T10/04-195r2 SAS-1.1 Internal Wide Connector/Cable Electrical Requirements

To: T10 Technical Committee
 From: Barry Olawsky, HP (barry.olawsky@hp.com)
 Date: 2 August 2004
 Subject: T10/04-195r2 SAS-1.1 Internal Wide Connector/Cable Electrical Requirements

Table — Internal 4-lane Cable/Connector Solution Electrical Requirements

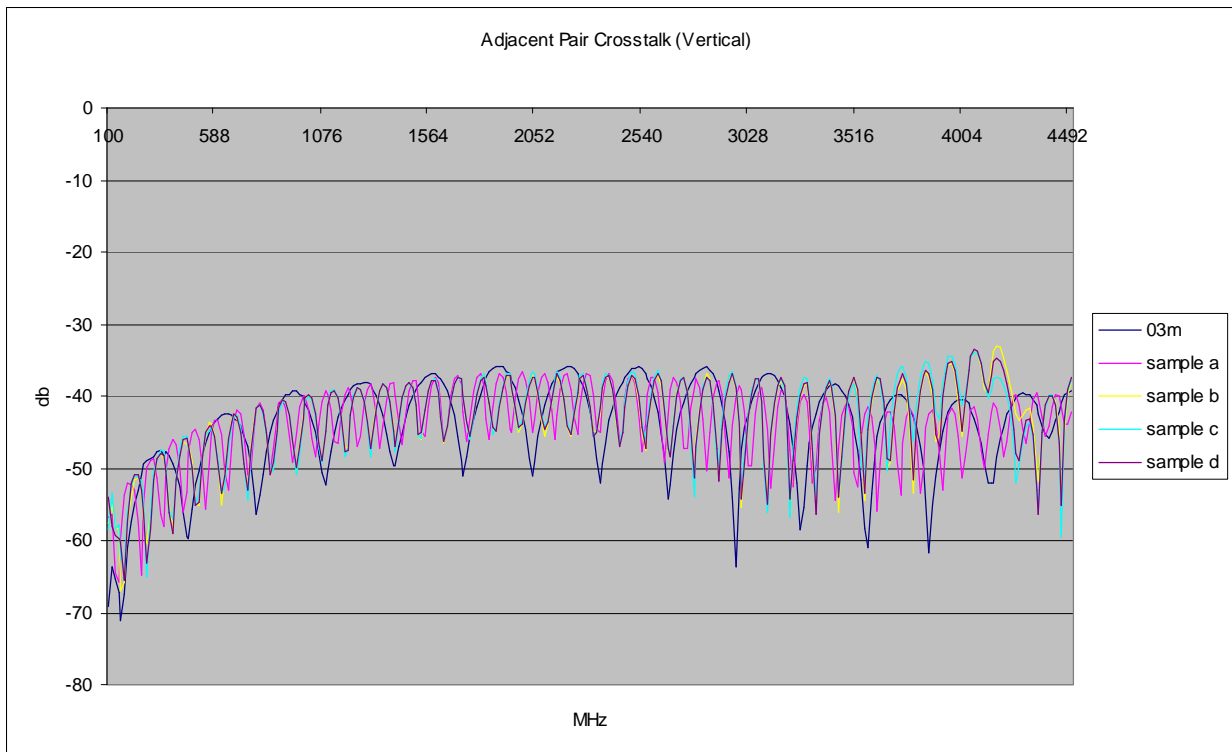
Add the following table to section after impedance requirements table.

Requirement	Units	1,5 Gbps	3,0 Gbps
<u>Equivalent</u> Time domain reflectometer rise time 20 % to 80 % ^{a, b}	ps	70 (max)	70 (max)
Media (PCB or cable)			
Differential impedance ^{b, c, d}	ohm	100 ± 10	100 ± 10
Differential impedance imbalance ^{b, c, d, e}	ohm	5	5
Common mode impedance ^{b, c, d}	ohm	32,5 ± 7,5	32,5 ± 7,5
Mated connectors			
Differential impedance ^{b, c, d}	ohm	100 ± 15	100 ± 15
Mated Cable Assembly			
Maximum Insertion Loss ^{b, f}	db	6	6
Maximum Near-End Crosstalk (adjacent pairs) ^{b, f, g}	db	33	33
Maximum Near-End Crosstalk (between pairs differential signal pairs 1, 2, 3 and 4) ^{b, f, g}	db	45	45
Maximum Near-End Crosstalk (between differential signal pairs 5, 6, 7 and 8) ^{b, f, g}	db	45	45
Maximum Near-End Crosstalk (all other differential signal pair combinations) ^{b, f, g}	db	50	50
Maximum Intra-Pair Skew ^b	ps	10	10
^a All times indicated for time domain reflectometer measurements are recorded times. Recorded times are twice the transit time of the time domain reflectometer signal. Filtering may be used to obtain the equivalent rise time. The filter consists of the two-way launch/return path of the test fixturing, two-way
